ADDENDUM NO. 02 TO THE CONSTRUCTION DOCUMENTS BID PACKAGE

Client: Arrowhead Regional Medical Center

Project: Oncology-Ambulatory Clinic

SHA Project No.: 18242.100

INTERIOR ELEVATIONS

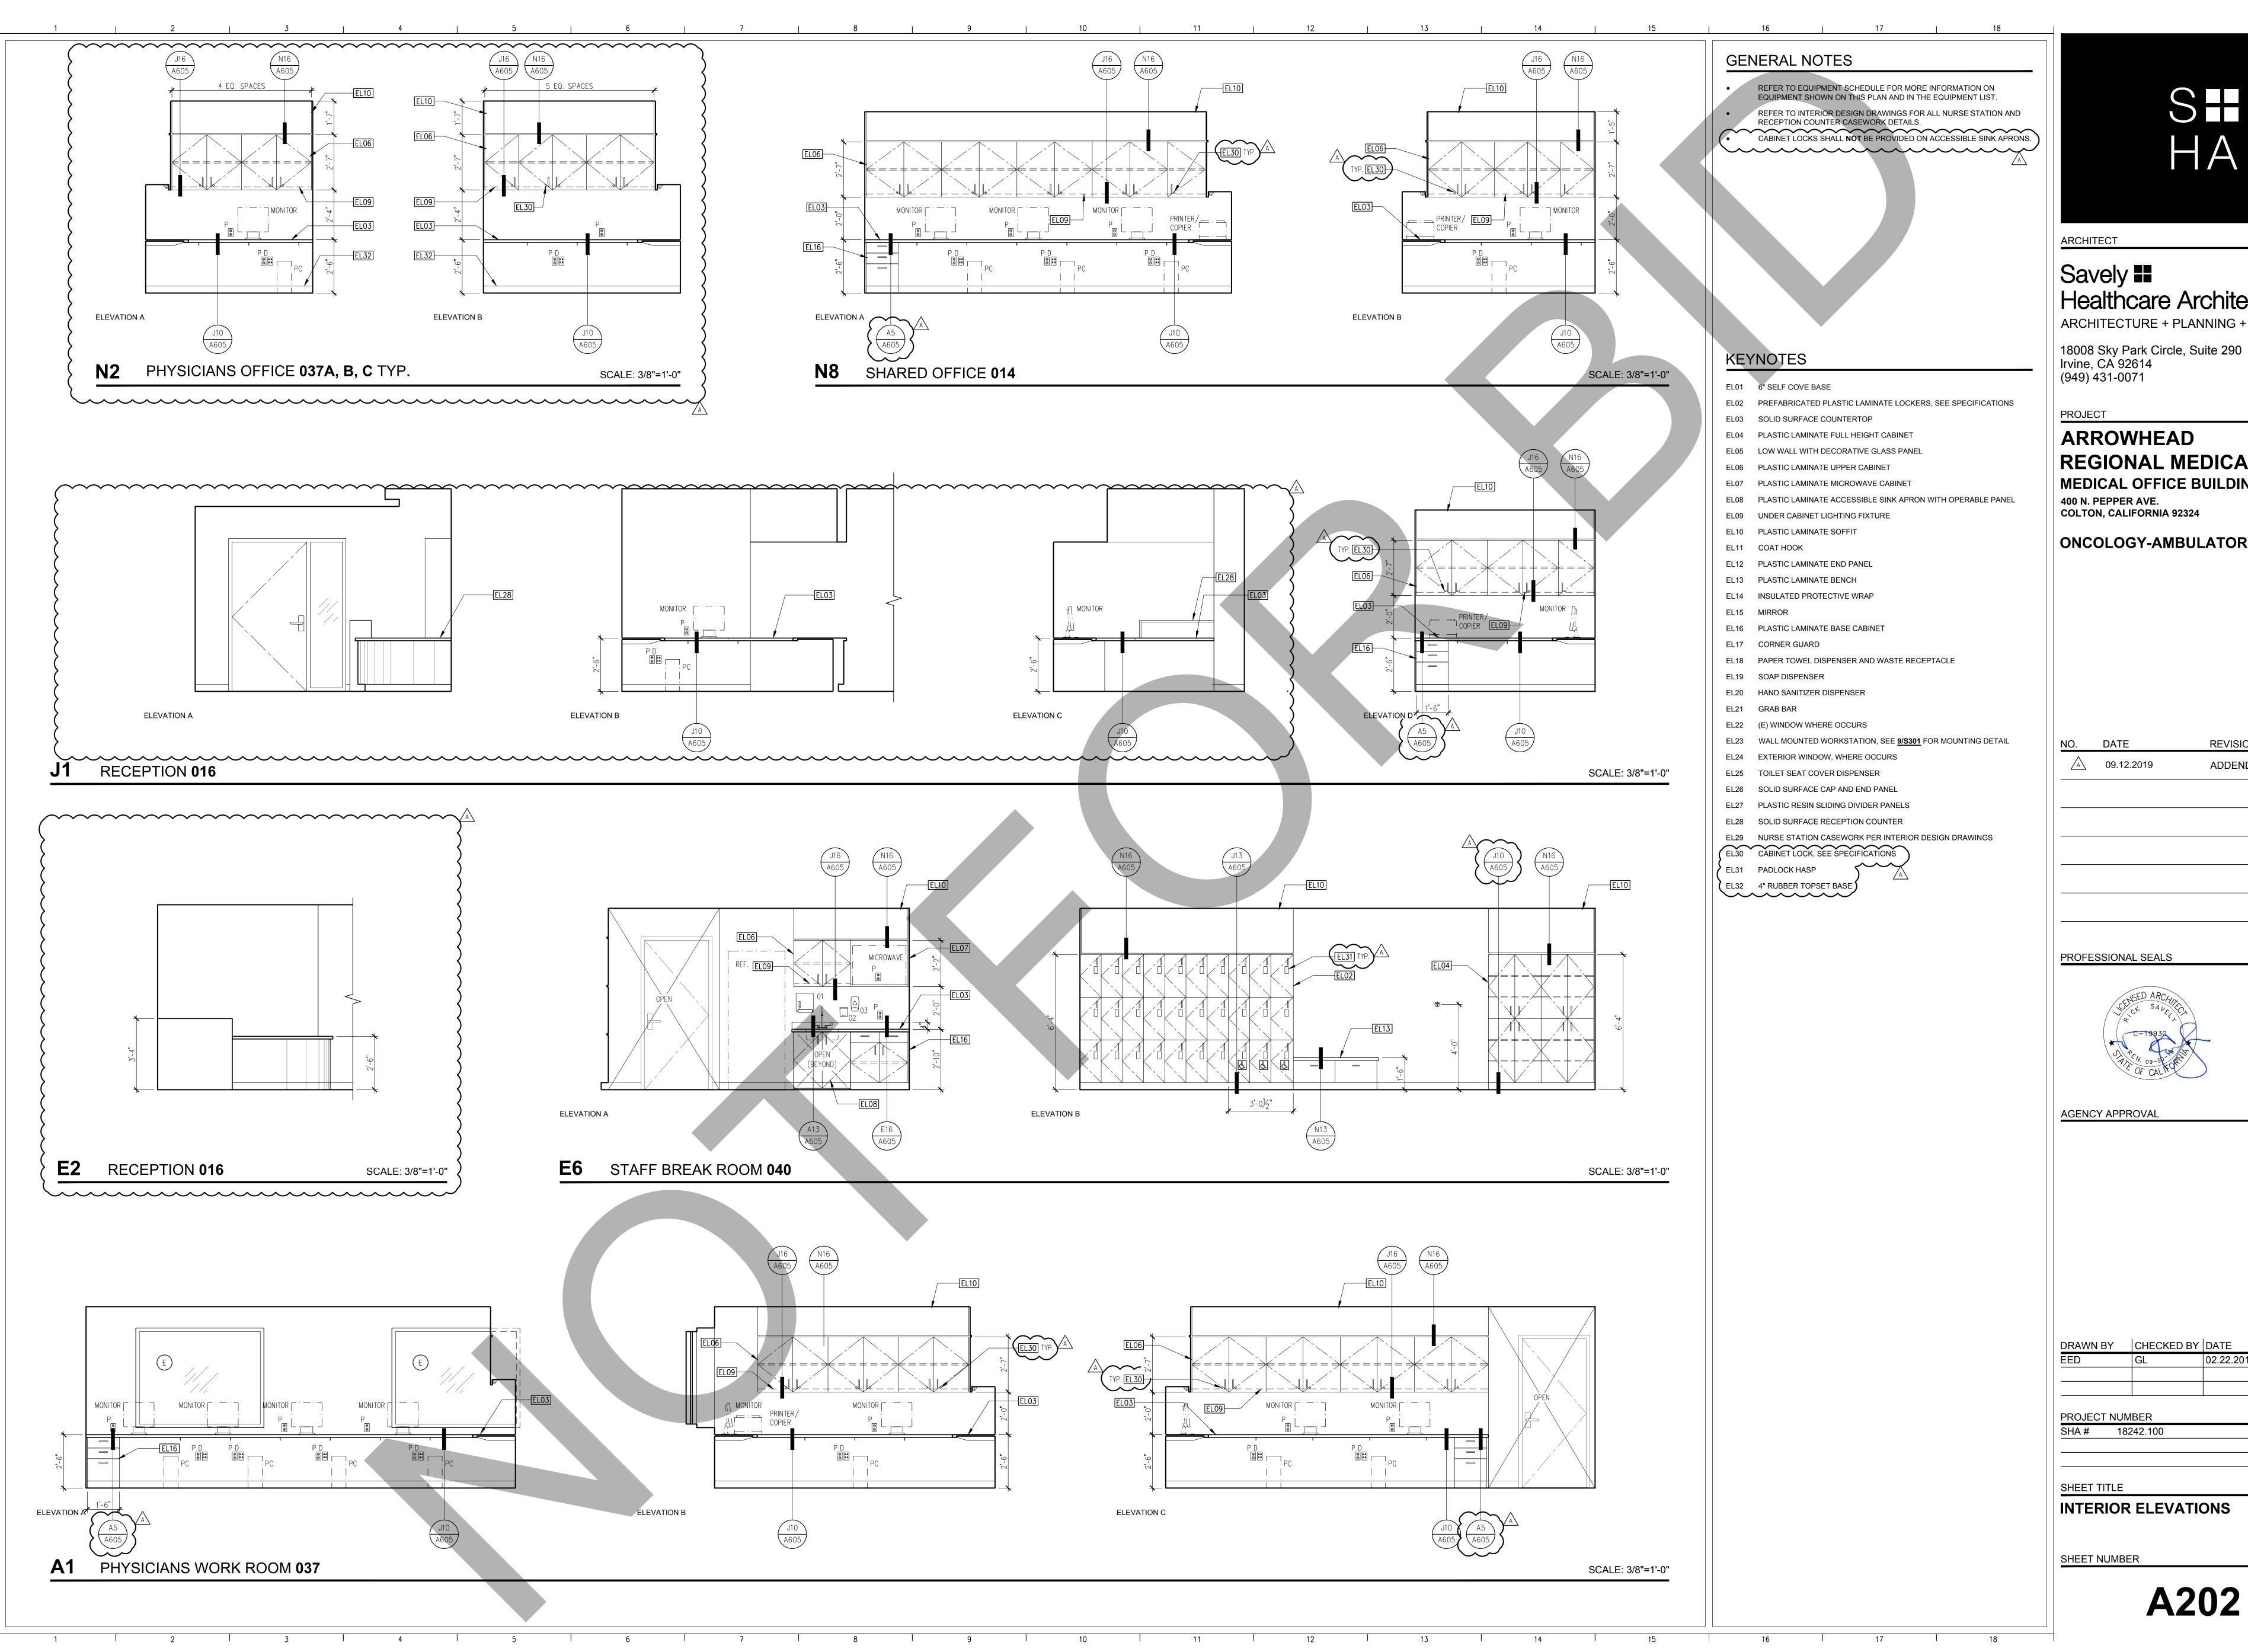
- A201 Clinical Assistant 018 Interior Elevation E added to sheet at N2/-. Cabinet locks added to various elevations and Keynote EL30 added to Keynotes. General Note prohibiting cabinet locks at accessible sink aprons added to General Notes. Detail callout revised to reference correct detail.

003.1	Section 064100/2.3.G.13.a, indicates cabinet locks as indicated on drawings. Interior elevations and casework details do not show locks. Please clarify the locations of any casework locks.	Cabinet locks are to be provided per the attached revised interior elevations.
	Section 064100/2.3.G.6 & 7, indicate keyboard trays and articulating keyboard supports.	Keyboard trays and supports are not part of this contract, and have been removed from

FLOOR PATTERN & ACCENT WALL FINISH PLAN

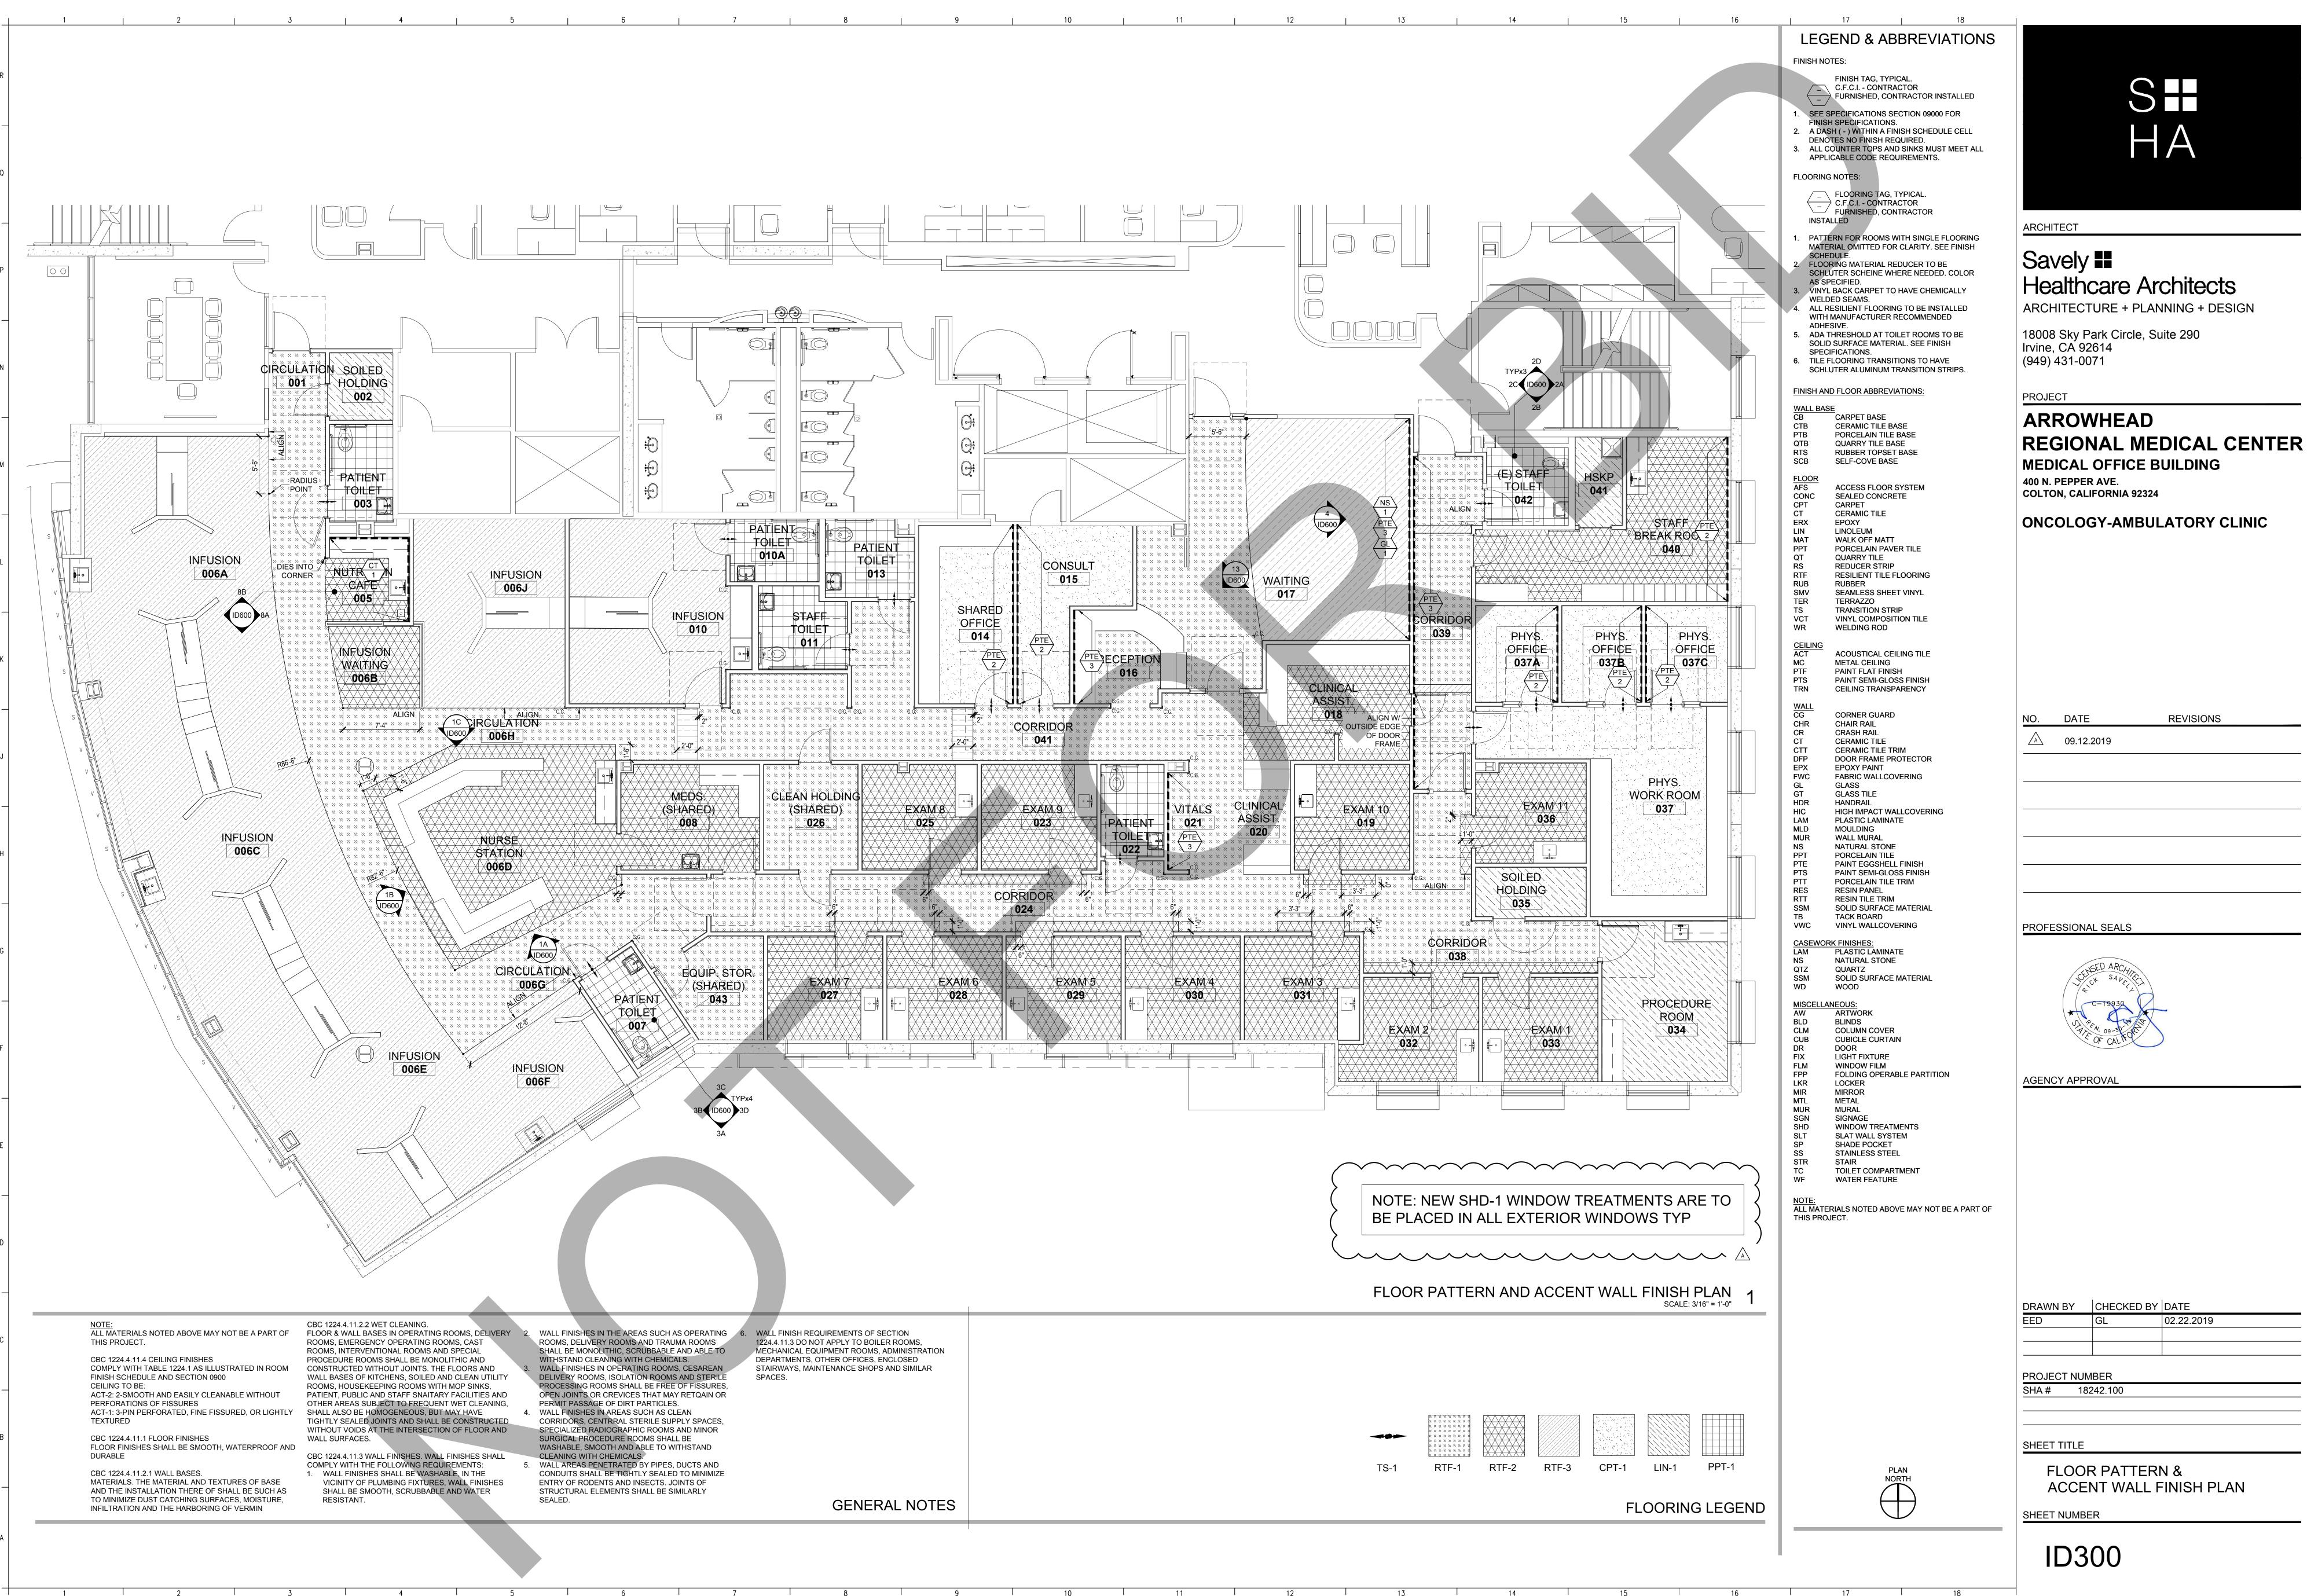
- ID300 Added Note to plan regarding Window Treatments.
- **ID600** Typical Toilet Room Interior Elevations revised to match Architectural drawings.

005.1	calls for Window Treatment SHD-1 to match building standards, but there are no call outs on the drawings.	Interior Design drawings and Specification Sections attached.
